# DeIDOT Standard Details Update for MASH 2016

## MASH 2016 Update Committee

- Started late 2018
- Consists of members from Bridge, Project Development, Construction, Maintenance, Consultants.
- Intent is to update the Standard Details to MASH compliant designs.
- Department wide effort.

Standard B-1:  
Types 1-31, 2-31,  
and 3-31  
Guardrail  
Applications

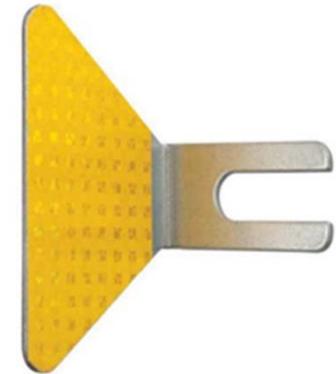
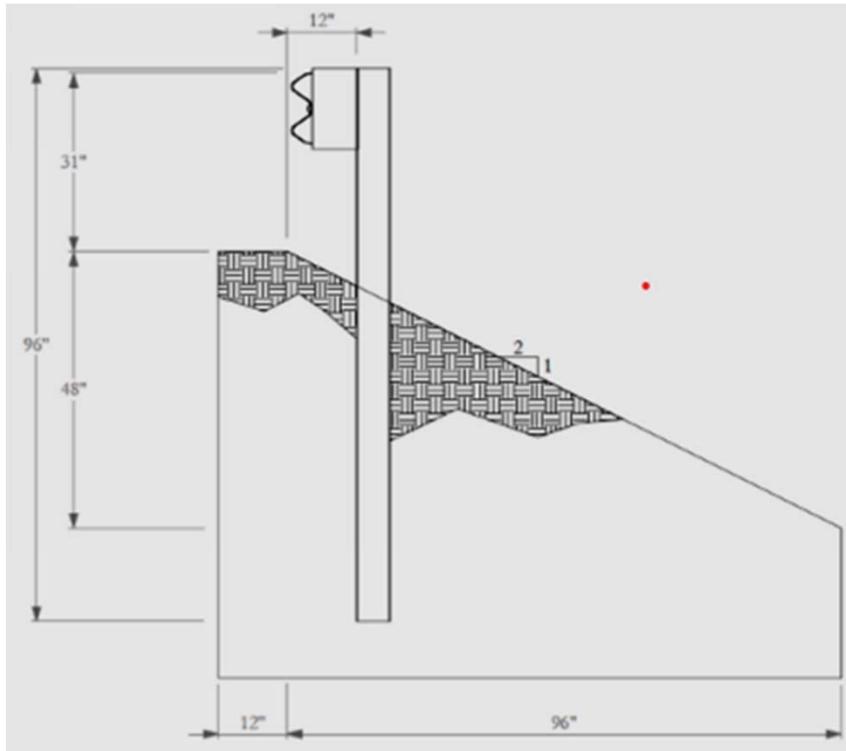
**Sheet 1 of 3 – minor revisions to existing sheet**

**Sheet 2 of 3 – no changes anticipated**

**Sheet 3 of 3 – revisions to existing sheet to reflect MASH tested devices**

- Adding Guardrail on 2:1 Slope
- Guardrail with a one post omission
- Note for butterfly reflectors to be placed at the guardrail splice point

Standard B-2 Grading for Guardrail End Treatment Attenuator, Types 1, 2, and 3 (3 sheets)

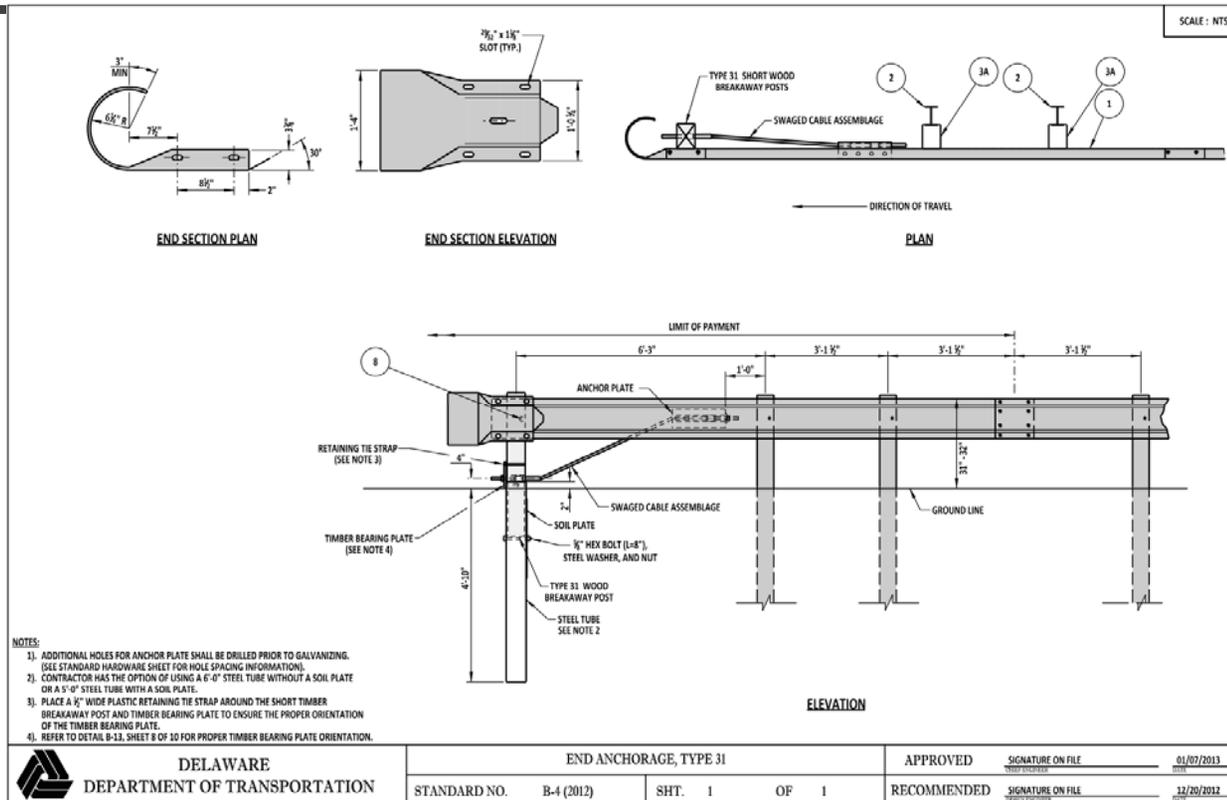
- Sheets 1, 2 and 3 – minor revisions to existing sheet
- Access the Approved Product List.
- Use the grading detail OR FOLLOW THE MANUFACTURERS RECOMMENDATIONS.

# **Standard B-5 Guardrail to Barrier Connection, Approach Type 1-31 and 2-31**

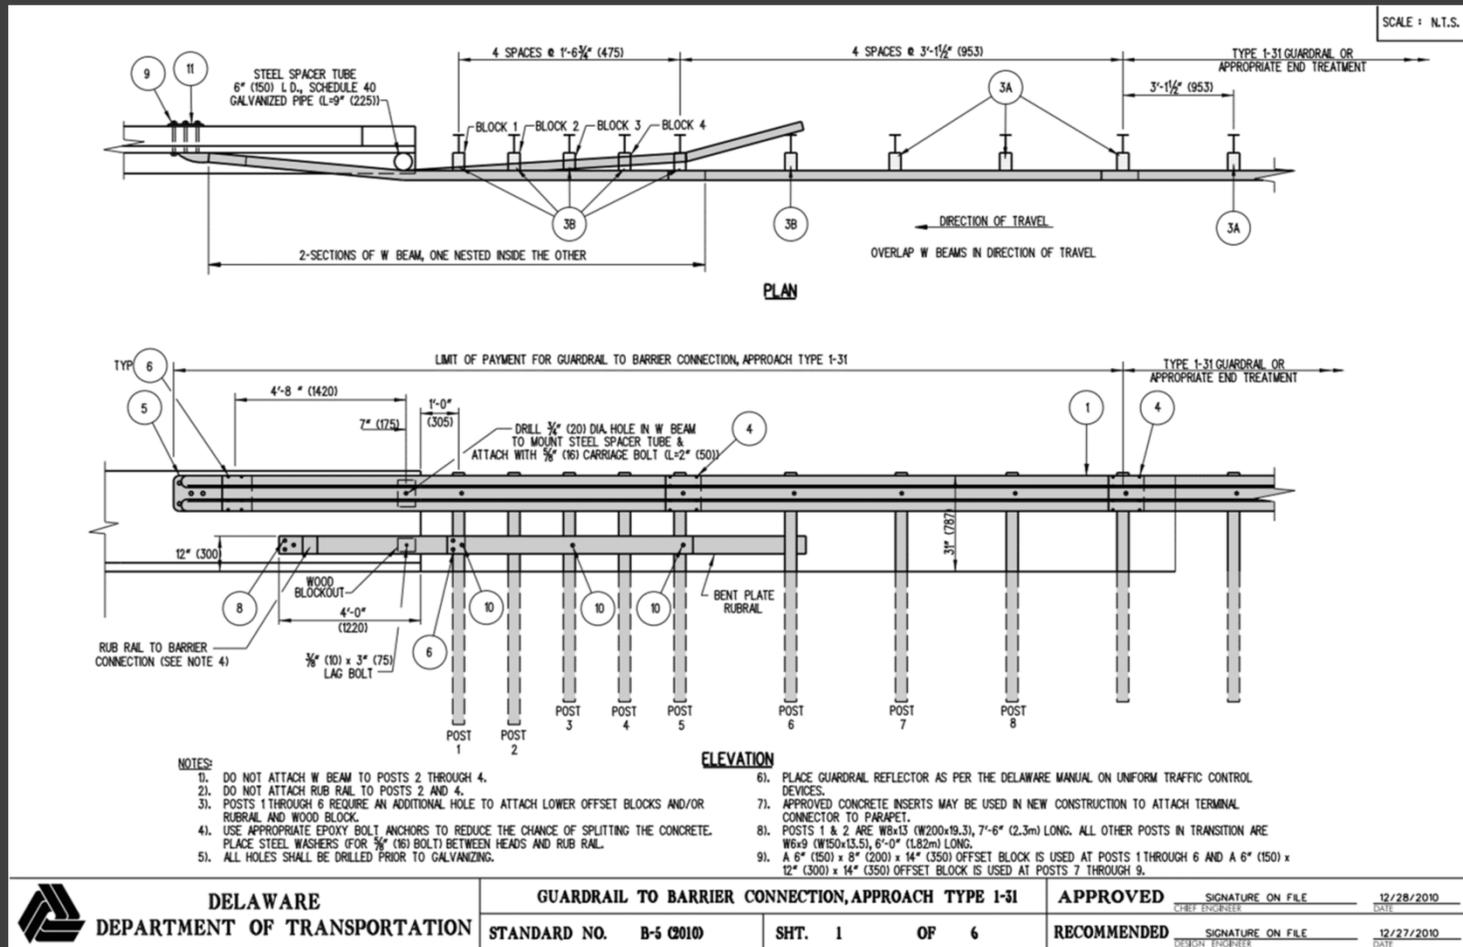
- Approach Type 2-31, Sheets 4 and 5 will be replaced.
- Sheet 6 of 6 will remain with minor revisions to existing sheet
- In lieu of the Approach Type 2-31, new details for Guardrail to Barrier Connection Approach will be developed:
  - 34" Tall Thrie Beam Transition to Concrete Buttress
  - 31" Tall Thrie Beam to Barrier Connection

Standard B-6  
Bridge Rail Retrofit

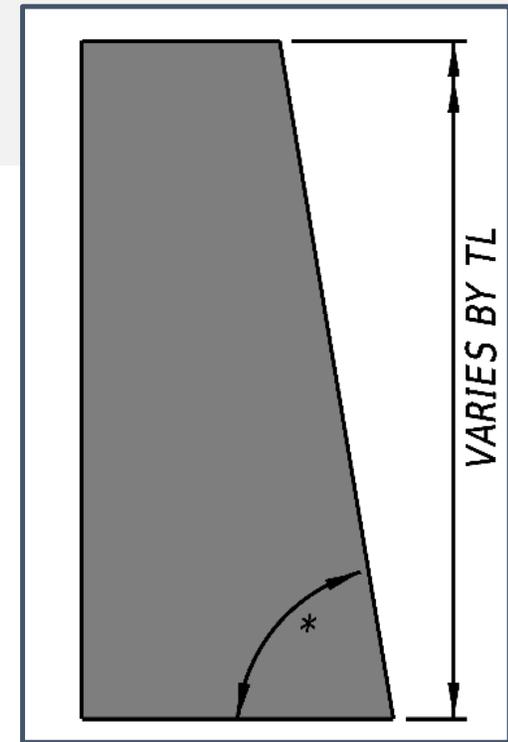
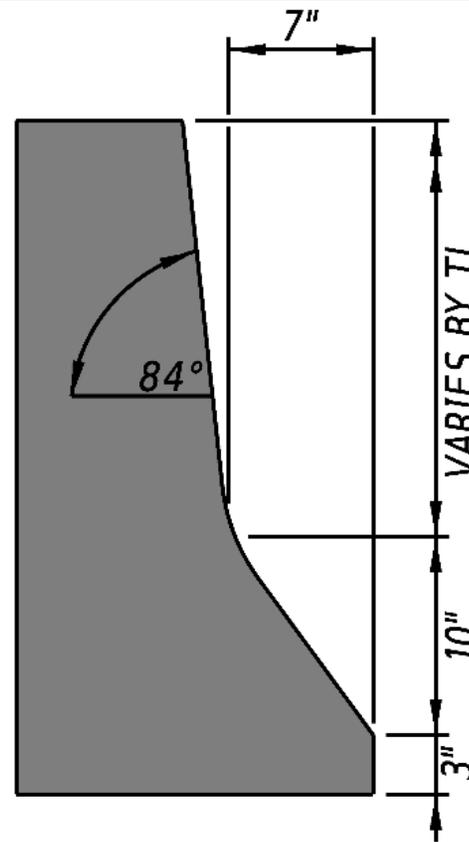
Remove

- All 5 sheets will be deleted.
- Any bridge retrofit will be designed specific to the bridge
